BALLARD MINE

SUPPLEMENTAL TECHNICAL MEMORANDUM
MONITORED NATURAL ATTENUATION REMEDY FOR
GROUNDWATER

FINAL – REVISION 2

COMMENTS AND COMMENT RESPONSE DOCUMENTS

Figure 3-3. Plot of Total Selenium Concentrations Over Time in Wells Formation Monitoring Locations

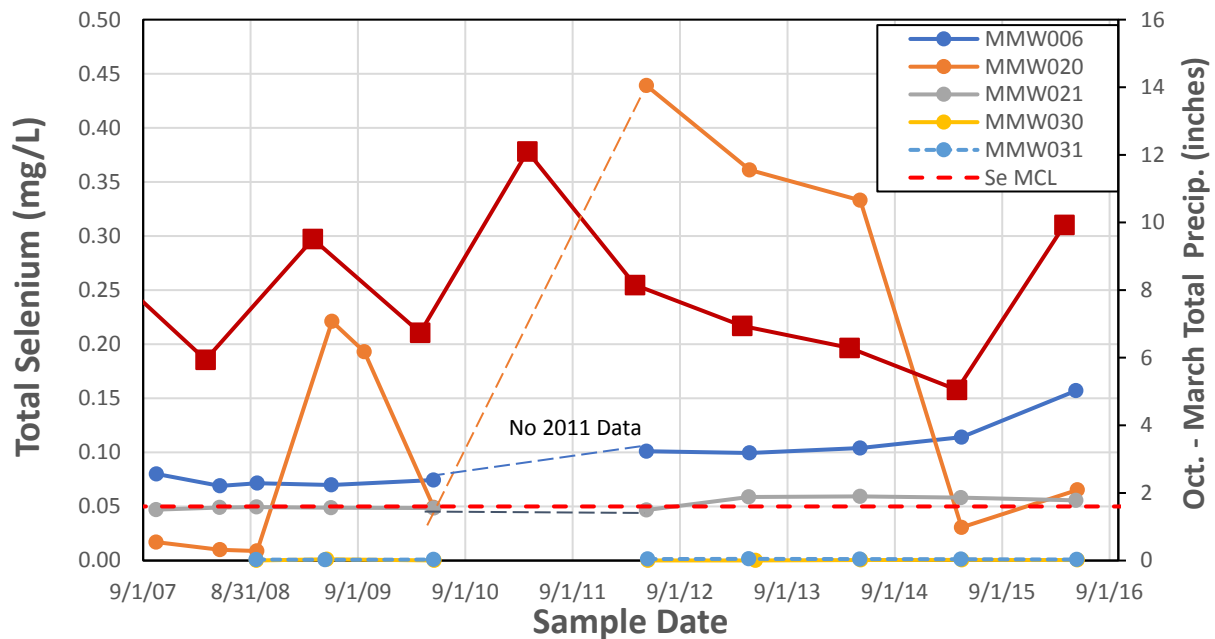
11. P. 3-12, “Contaminant Trends” subheading, last paragraph. The statement about the response at MMW006 and MMW021 to elevated Se concentrations at MMW020 does not appear to be well-supported by the data in Figure 3-3; in fact, it is difficult to discern any clear relationship between those data sets. A different possible interpretation of the data for MMW006 is that they seem to have an increasing trend. This is not mentioned in a discussion of plume stability like that presented for alluvial groundwater. If this trend were considered an indication of a potentially expanding plume (e.g., since a lack of an increasing concentration trend is taken to suggest a static plume and attenuation earlier in the TM for the alluvial groundwater), would that call into question the statement on p. 3-6 concluding that the data for MMW030 suggest that Se contamination in the Wells Formation groundwater is confined near the West Ballard Pit? Please present this interpretation as a hypothesis, and acknowledge and disclose uncertainty.

11. Sec. 3.2.2, paragraph after Figure 3-3. Saying that MMW006 and MMW021 show a lagged/muted response to concentrations in MMW020 seems like a stretch based solely on the data plotted in Figure 3-3. Recommend re-ordering the list of bullets, as it may be more credible to make that statement after you’ve presented the hypothetical explanation as found in the subsequent bullets.

P4 Response (SC-11): *Interpreting data for the Wells Formation is difficult, because, as stated in the memo, the monitoring wells are installed within different stratigraphic levels in the Wells Formation and in some cases are separated by faults. However, the statement regarding the response in selenium concentrations in MMW006 also is based on other data presented in the Ballard Mine RI Report. Based on geological and potentiometric data, only MMW006 and MMW021 appear to be in a similar hydrogeologic unit as detailed in Section 5.1.5.4 of the Ballard Mine RI Report (Figure 5-1 attached below). Each of the Ballard Site wells installed in the Wells Formation monitoring network responded to the large 2011 recharge event and provided some important information regard the hydrogeology of this deeper aquifer.*

- It is reasonable, and even probable, that both MMW006 and MMW021, respond to increases in concentrations observed at MMW020 in a more delayed manner as flow has been transported across lower permeability bedding within the formation. The new cross-section that will be added to the memo will be used to help illustrate this concept of cross bedding flow (new Drawing 3-2, see response SC-5).
